**ARCHITECT'S SUPPLEMENTAL
INSTRUCTIONS
Bid Addendum No. 01**

Publish Date: 07.20.15
RCA Job No: 201517

PROJECT: Toni&Guy Hairdressing Academy	OWNER: Toni&Guy
PROJ. ADDRESS: 2200 Eastridge Loop #1004 San Jose, California 95122	2765 Lavender Terrace San Jose, CA 95111
Issued By: Terry Smith O+714.832.3333	Owner Rep: Dalena Hoang O+510.209.0212

Sheet title:
FLOOR PLAN

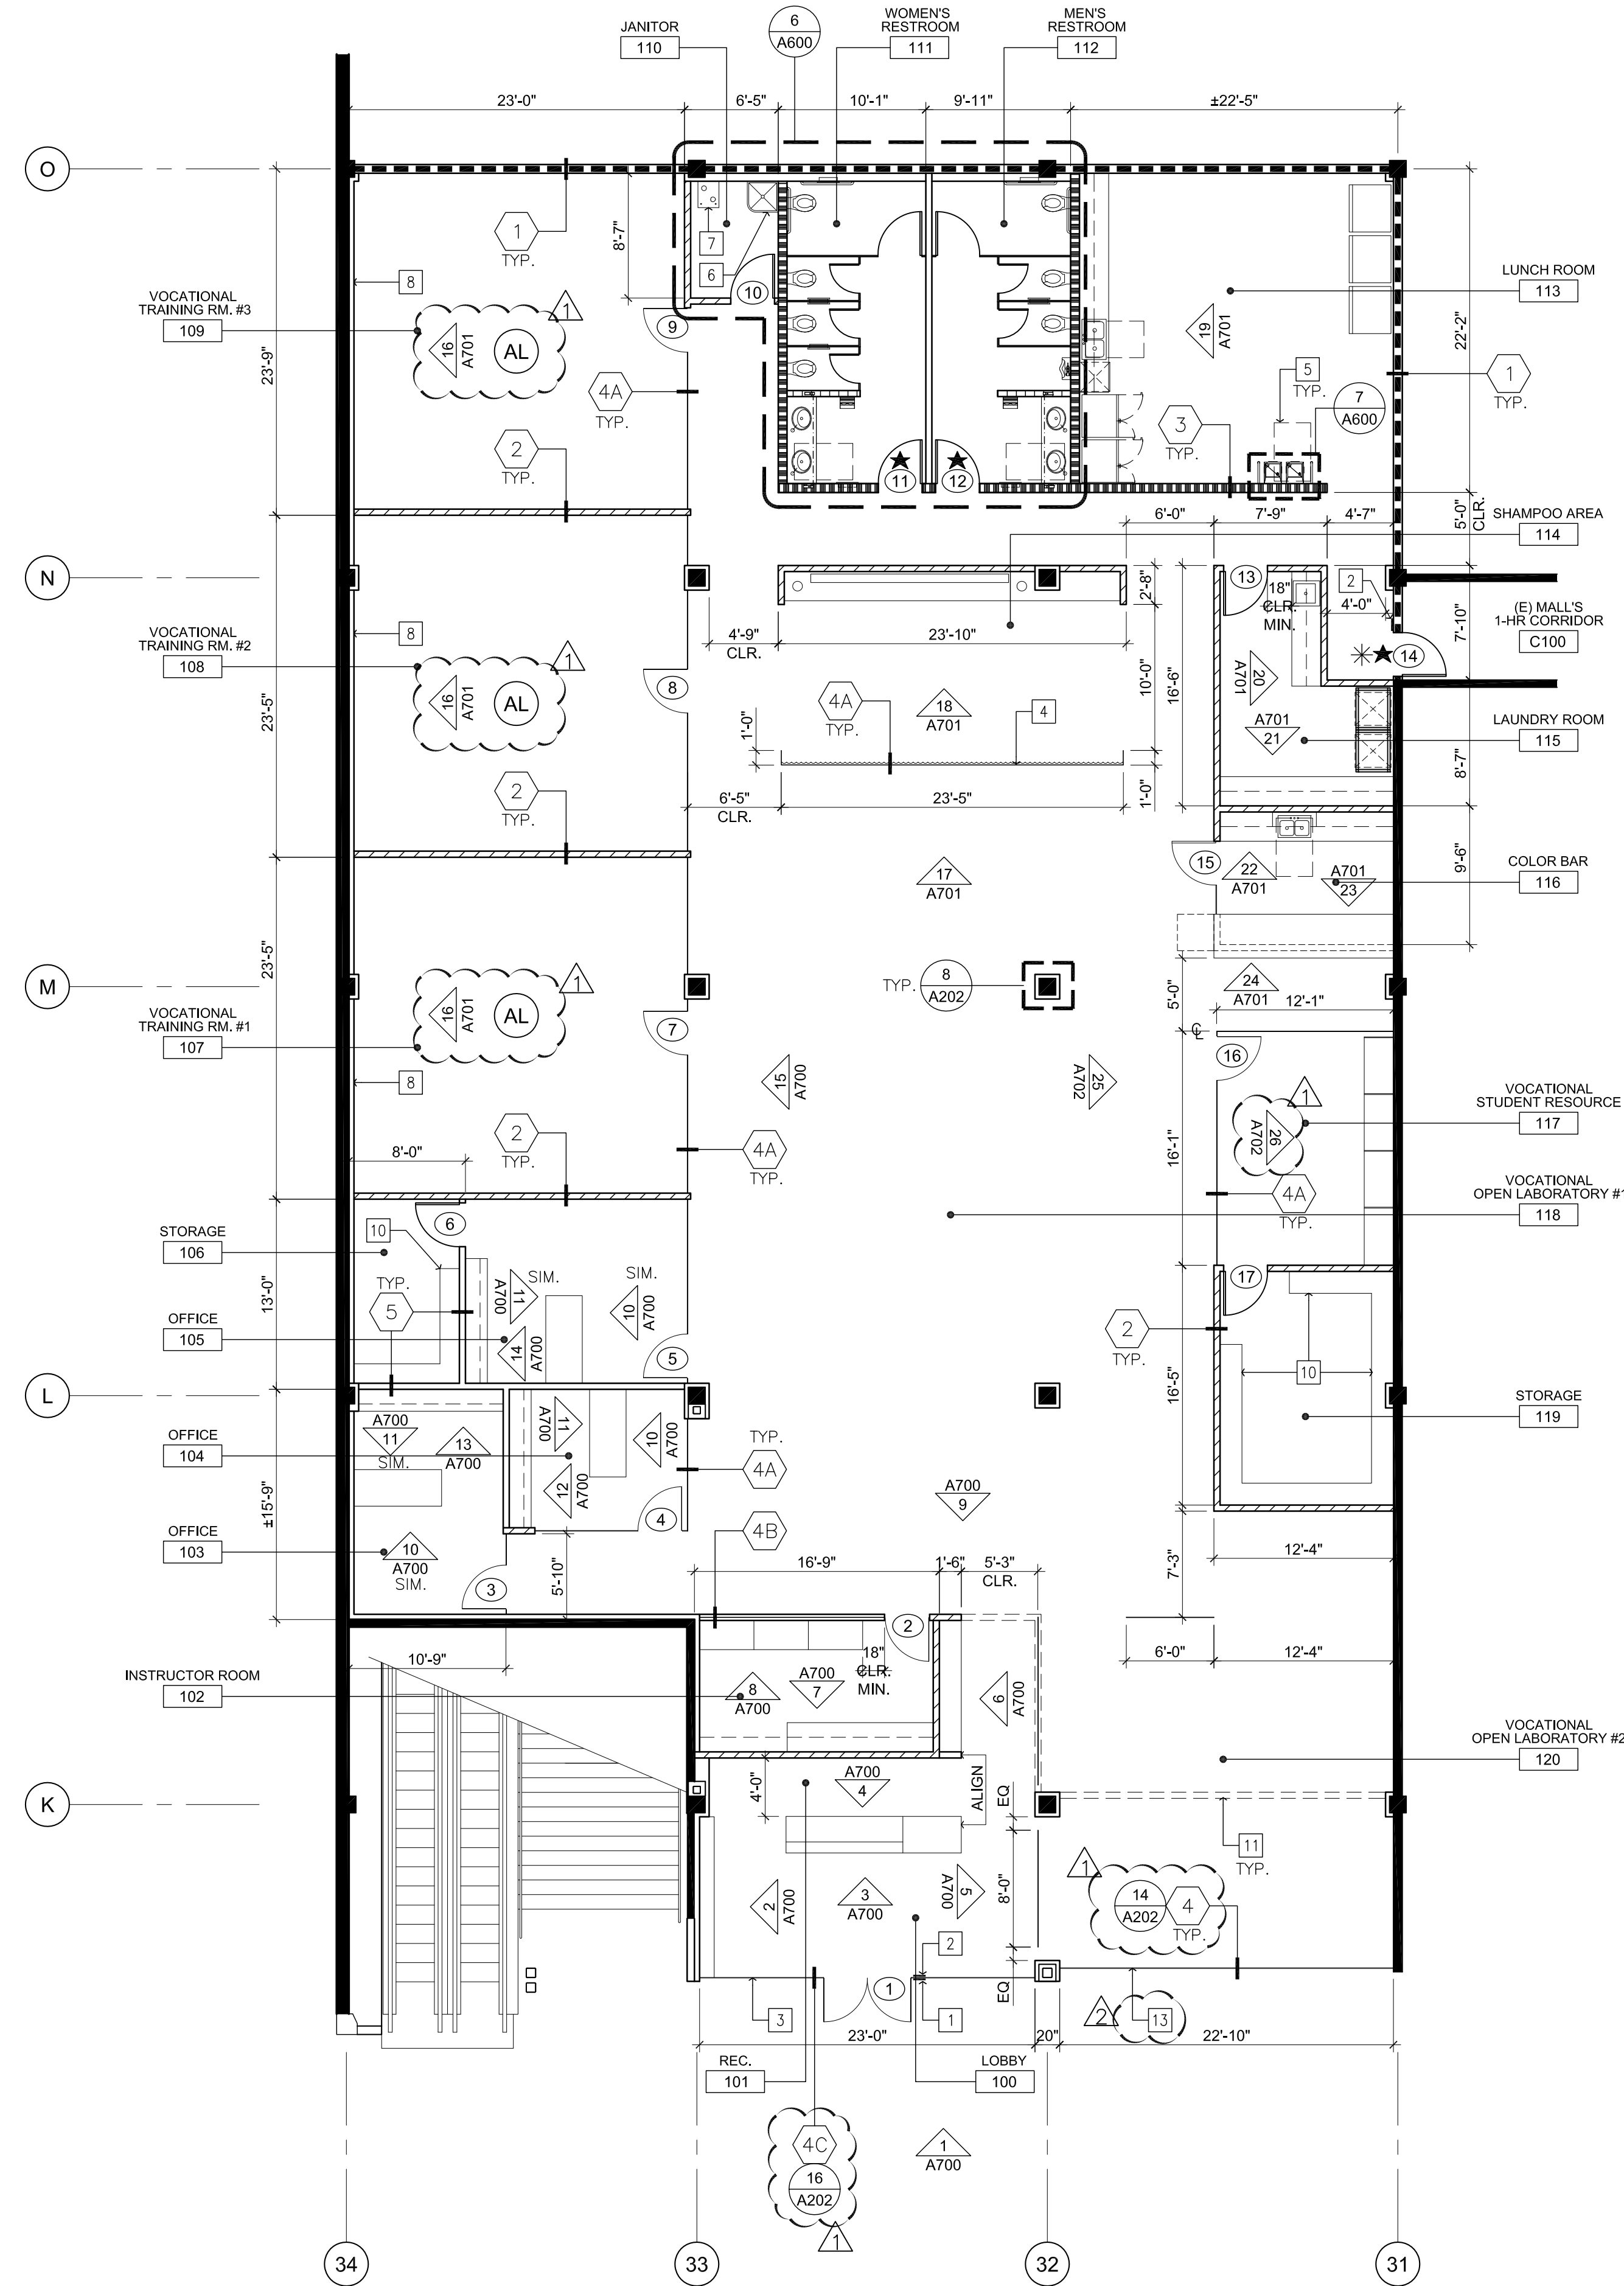
1.04	Contractor shall make provisions within their bid for responses to Bergman KPRS Bid-RFI #001 dated July 13, 2015. In addition to Rengel+Company, Architects' listed responses with this RFI, please refer to attached drawing sheets A301.

1.05	Contractor shall make provisions within their bid for responses to Bergman KPRS Bid-RFI #002 dated July 20, 2015. In addition to Rengel+Company, Architects' listed responses with this RFI, please refer to attached drawing sheets A200 'Partition Schedule, Partition 4', A202 Detail 14, and A301 'Key Notes, note 13'.

1. Who provides and installs shelving per key note #10 on A301?
2. Is fire tape finish on adjacent space okay at back demising wall? Or does it need level 5 finish as well?
3. Please confirm all interior walls & furring walls to receive R-13 insulation per partition schedule sheet A200.
4. Is the Demo to be done during off hours?
5. Is it possible to value engineer the finish floor and provide you with an alternate to epoxy entire floor? This will be very cost effective and it is easier to clean.

RFI Response:	<ul style="list-style-type: none"> __ Terry Smith, Rengel+Company, Architects 1.] Toni&Guy as noted. __ 2.] All partition walls shall be level 5 as noted. 3.] Confirmed, R13 batt insulation is for reducing sound transmission. __ 4.] Mall Management will need to confirm if required. 5.] No exceptions for the Flooring. This is a critical component for the __ branding of Toni&Guy. In addition, it has come to the attention of Rengel +Company, Architects that Eleganza Crystal White is no longer available. __ This product shall be replace with Eleganza Crystal Stone 2.0 24" x 24" tiles. Please make provisions within your bid for this product change. 		7.14.15
---------------	---	--	---------

13. NEW 3/4" TEMPERED HERCULITE GLAZING SYSTEM.
